**James Theatre Community Center
6 Brown Street Dungog 2420**

Proposed Artists Toilet - Detail Sketch 1 A
A Dimensions Added

Floor Plan Scale - 1 : 25

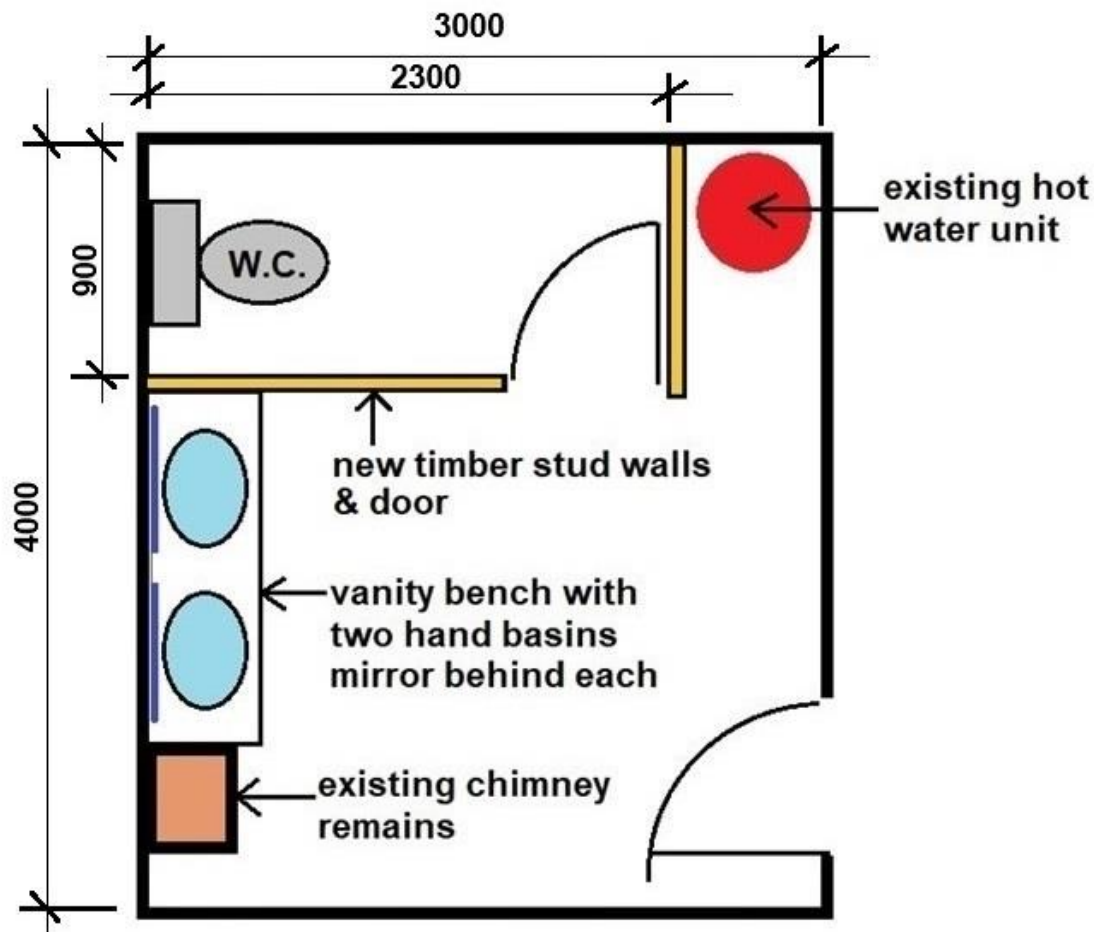
Added Information.

walls need to be lined

floor needs to have a waterproof finish with waste if required

plumbing is readily available from below

there are a number of routes for the w.c. to be drained as there are accessible voids below and ways for accessing sewer, in accordance with on site investigation.

provide a double GPO adjacent to the basins and one on the opposite wall
